DYER WHARF I-195 DESIGN PRESENTATION

2.2.2026

CV Properties LLC
DEVELOPMENT + INVESTMENT + MANAGEMENT

WAIVER 4 BLANK WALL, GROUND FLOOR TRANSPARENCY AND ENTRANCE REQUIREMENTS:

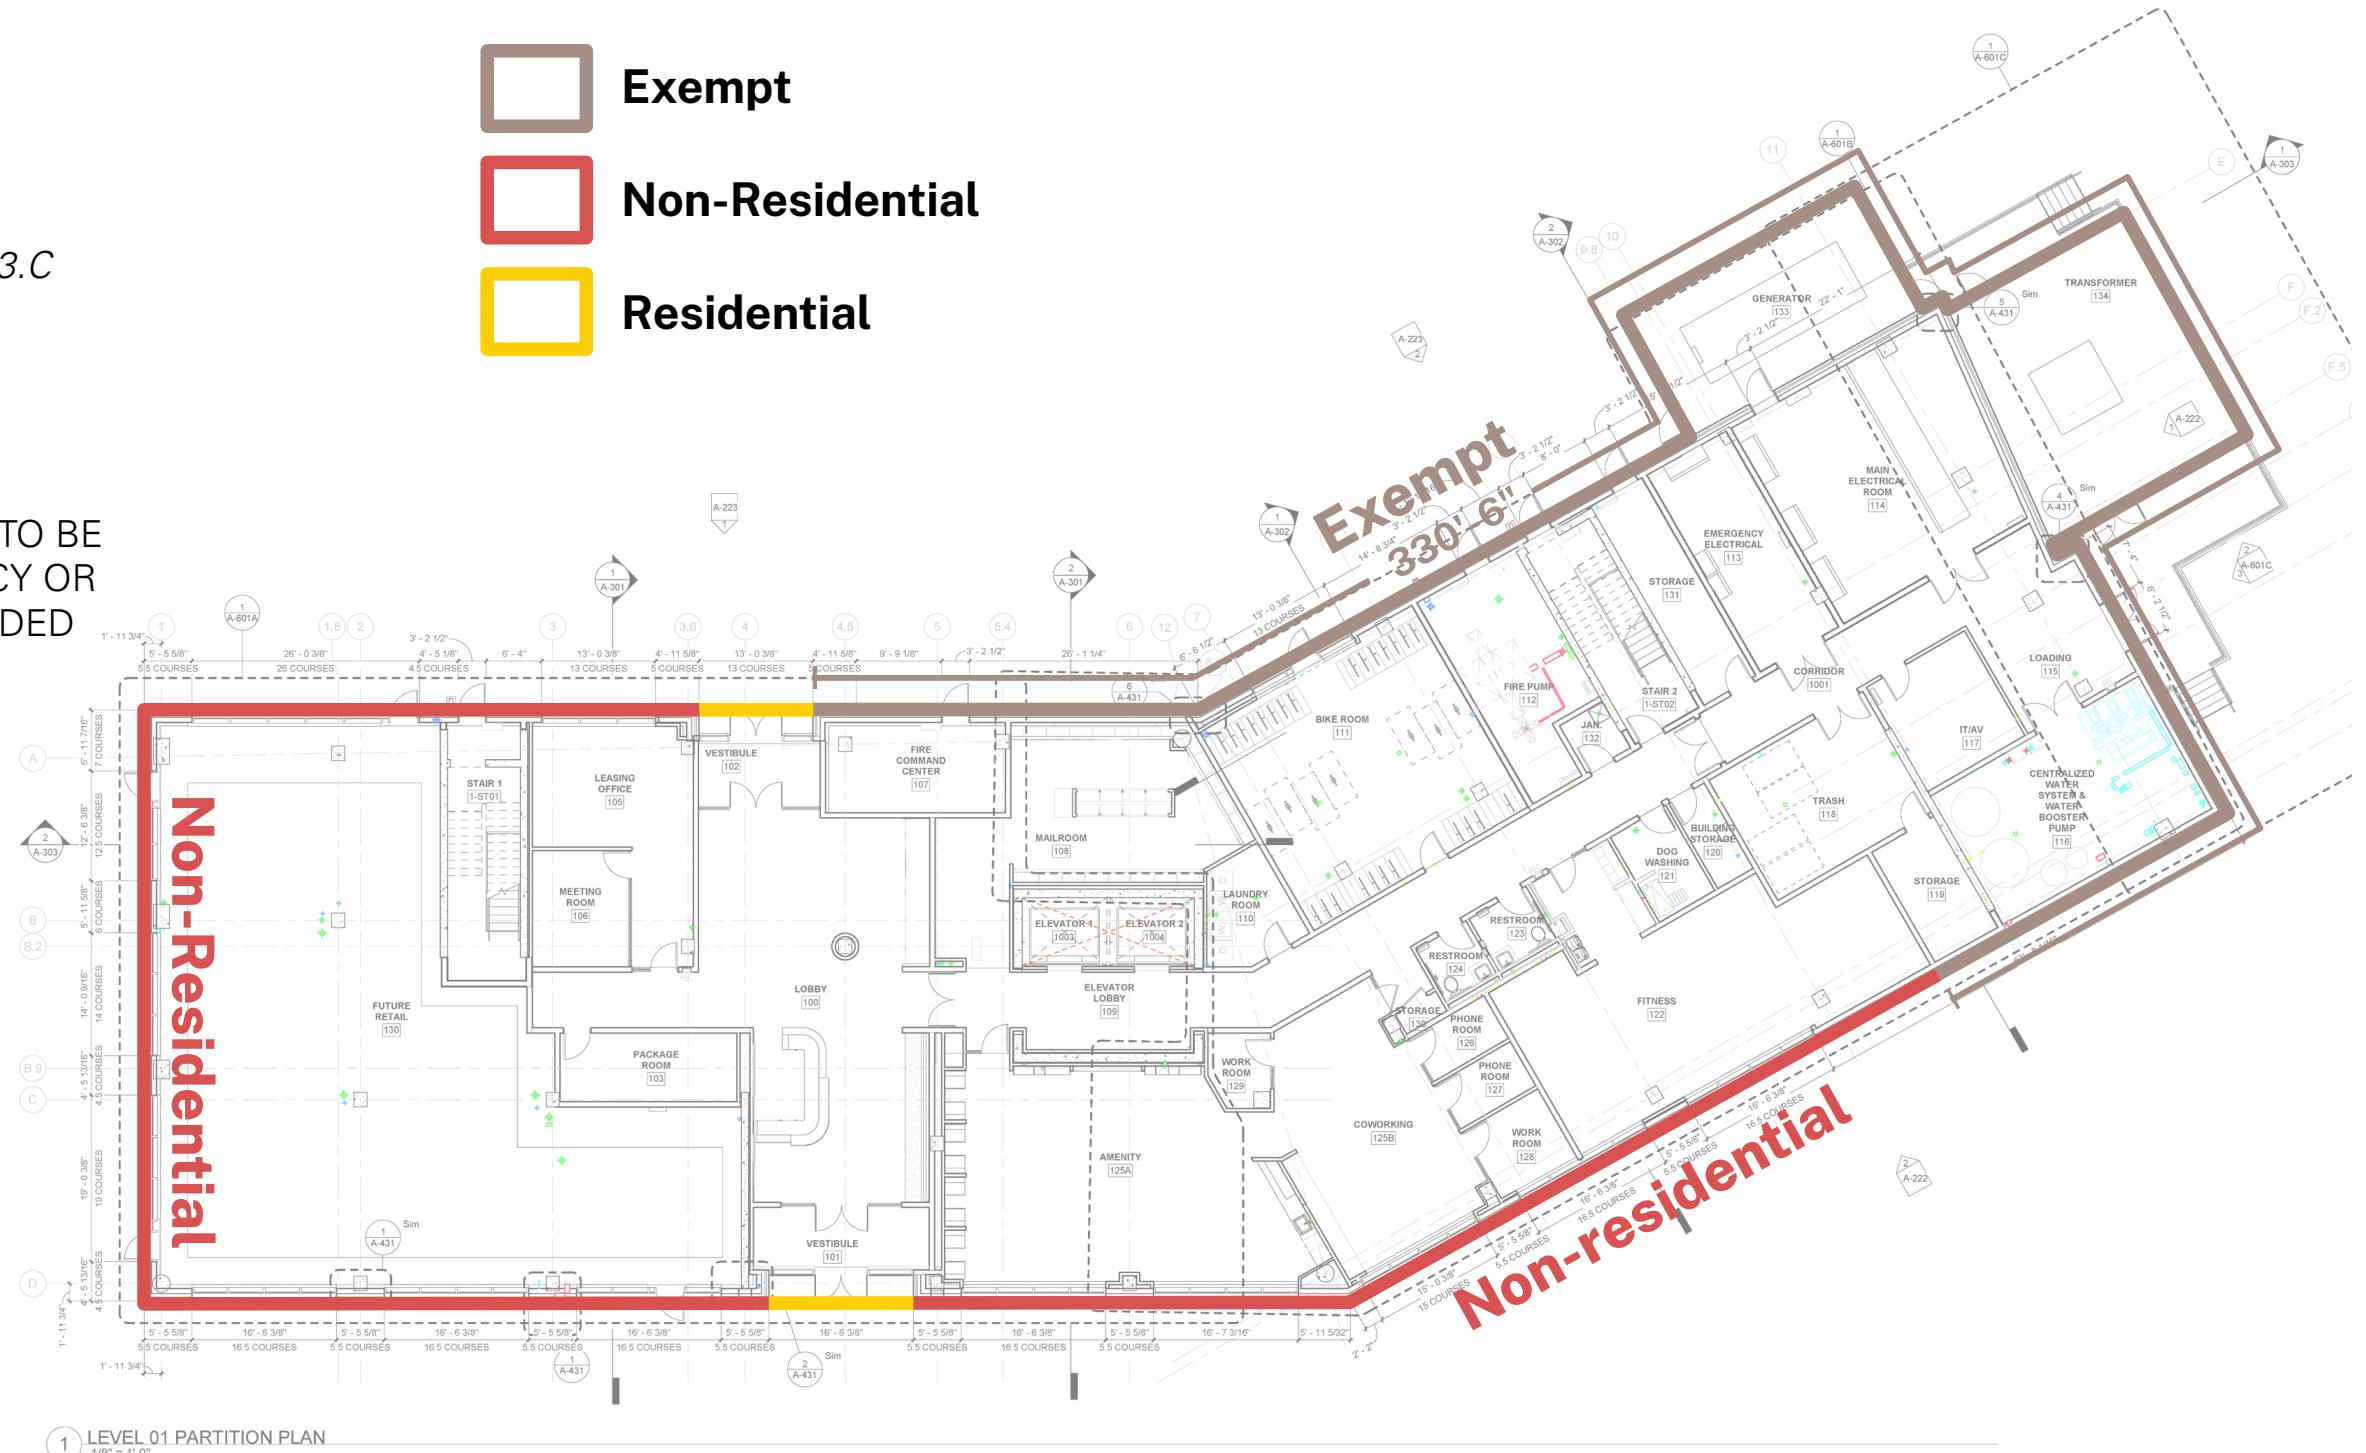
2.5 DESIGN STANDARDS,
SECTIONS 2.5.A.2.A, 2.5.A.2.B AND 2.5.A.3.C
(FIGURE 2.5-2)

ALLOW THE AREAS OF THE FAÇADE
ENCLOSING BACK OF HOUSE SPACES AS
INDICATED IN THE ATTACHED EXHIBIT 4,
MEASURING UP TO 330'-6" LINEAR FEET, TO BE
OPAQUE WALLS WITHOUT TRANSPARENCY OR
EXTERIOR BUILDING ENTRANCES, PROVIDED
THEY ARE SCREENED EFFECTIVELY BY
PLANTINGS.

WAIVER 5 CRITICAL SYSTEMS MEETING DESIGN FLOOD ELEVATION 2 (DFE-2):

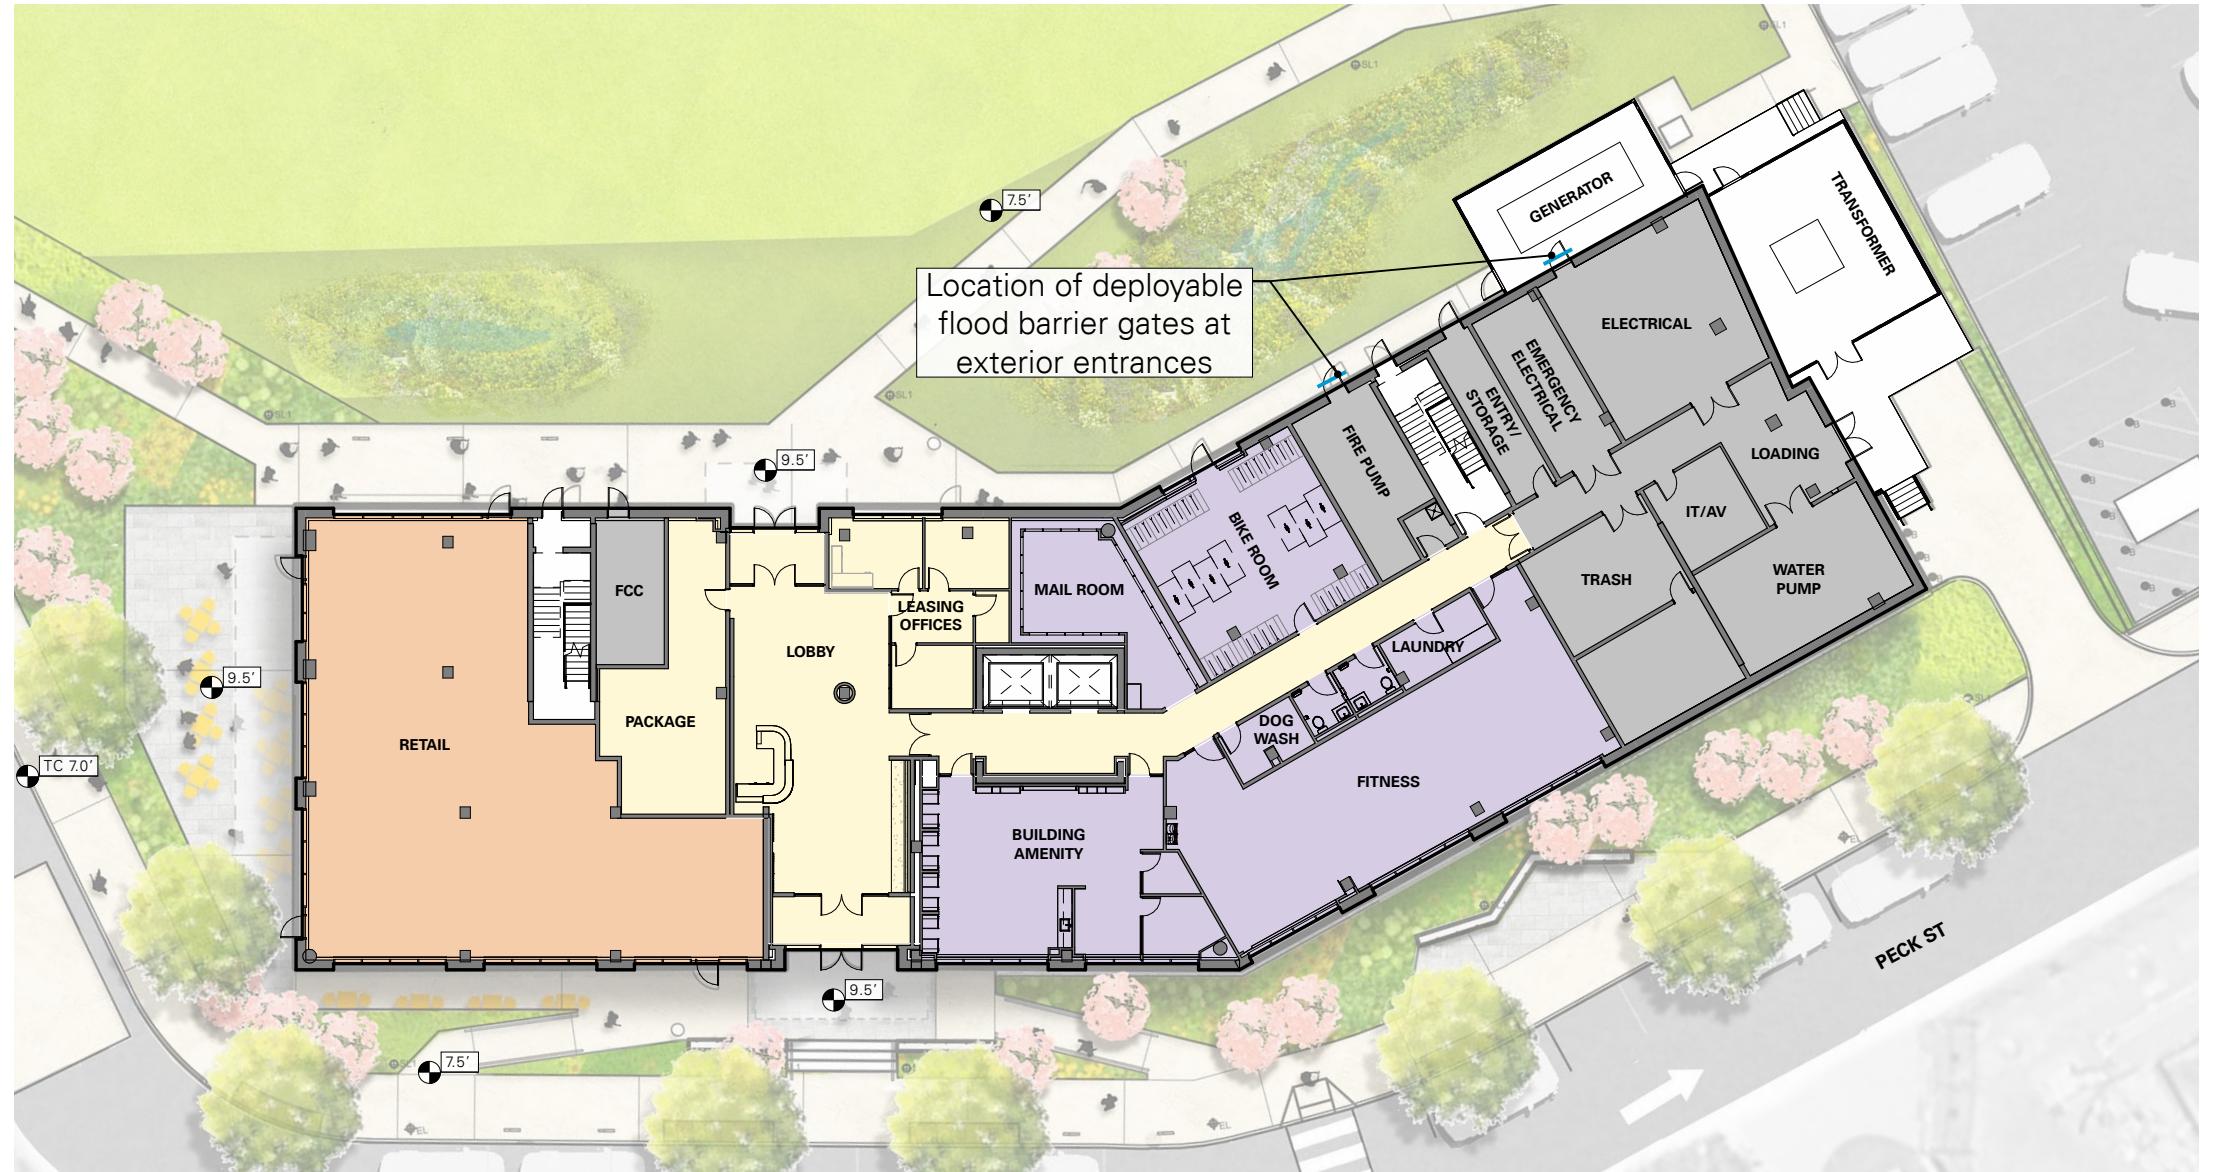
2.6 FLOOD RESILIENCE STANDARDS, SECTION 2.6.C.2

ALLOW CRITICAL MECHANICAL AND ELECTRICAL SYSTEMS TO BE LOCATED AT ELEVATIONS BELOW DFE-2, PROVIDED THAT DEPLOYABLE DRY FLOODPROOFING BARRIERS ARE INCORPORATED INTO THE DESIGN SUCH THAT THEY PROTECT THE MAIN ELECTRICAL EQUIPMENT, THE EMERGENCY ELECTRICAL EQUIPMENT, THE FIRE PUMP EQUIPMENT, IT/AV EQUIPMENT AND CENTRALIZED WATER SYSTEM, AND THE EXTERIOR PAD MOUNTED ELECTRICAL TRANSFORMER AND GENERATOR FROM FLOOD DAMAGE TO THE MAXIMUM DEGREE ALLOWABLE BY RI ENERGY.

WAIVER 6 HEIGHT OF FENCES AND WALLS

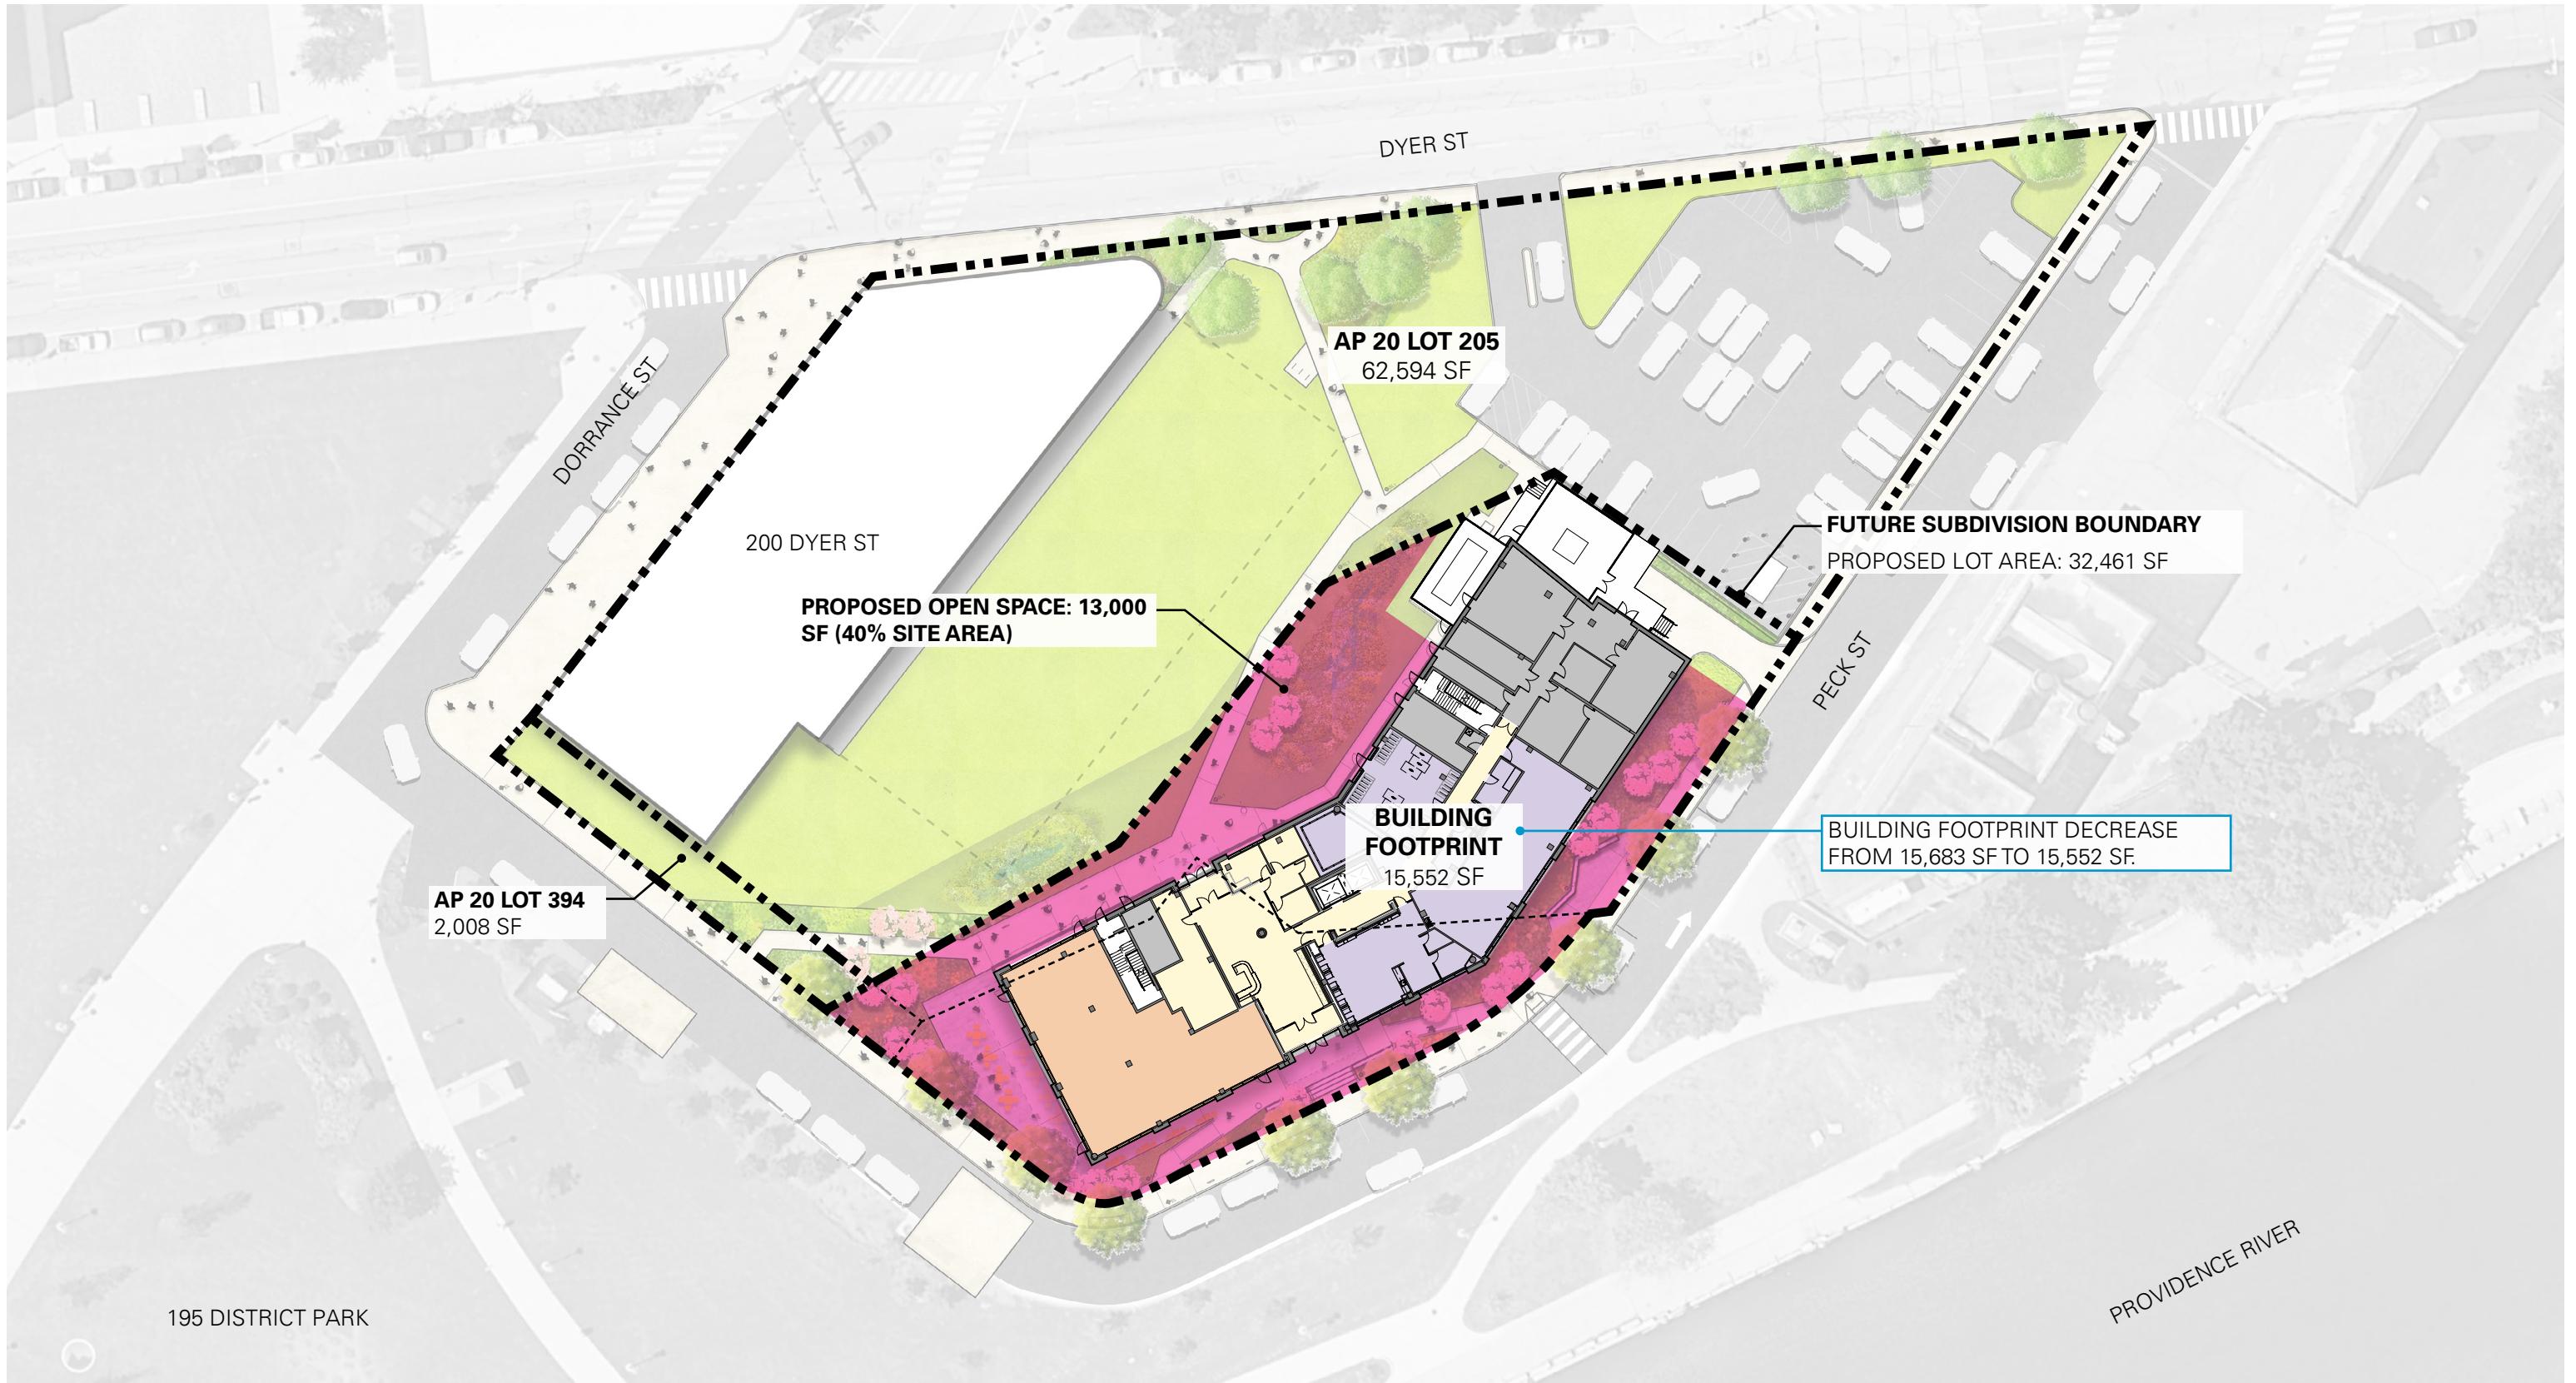
2.7 SITE IMPROVEMENTS, SECTION 2.7.B.1

SCREENING OF THE GROUND-MOUNTED TRANSFORMER AND GENERATOR IS ALLOWABLE UP TO THE MINIMUM HEIGHT NECESSARY TO SCREEN THE EQUIPMENT FROM PUBLIC VIEW AT EYE-HEIGHT FOR PEDESTRIANS STANDING ON PUBLIC RIGHTS OF WAYS AND WALKWAYS ABUTTING THE EQUIPMENT.

FACADE COMPARISON FACADE DETAIL AT GROUND FLOOR RETAIL

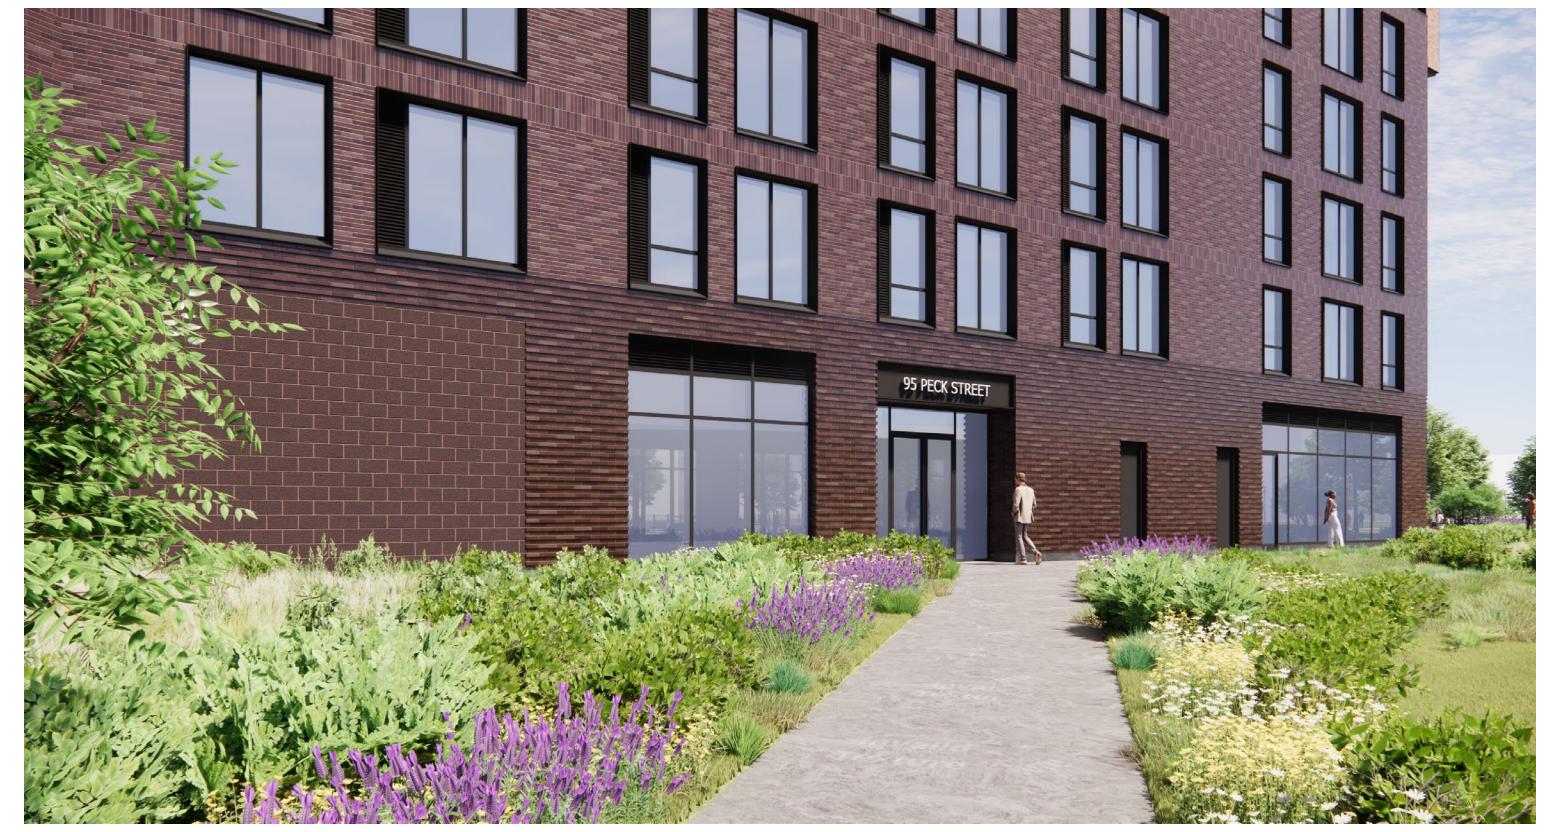
LOWER VOLUME SOUTH ELEVATION WINDOWS
ADJUSTED TO COORDINATE WITH UNIT LAYOUT
HORIZONTAL LOUVERS IN CANOPY CHANGED FROM
WOOD COLOR TO DARK BRONZE
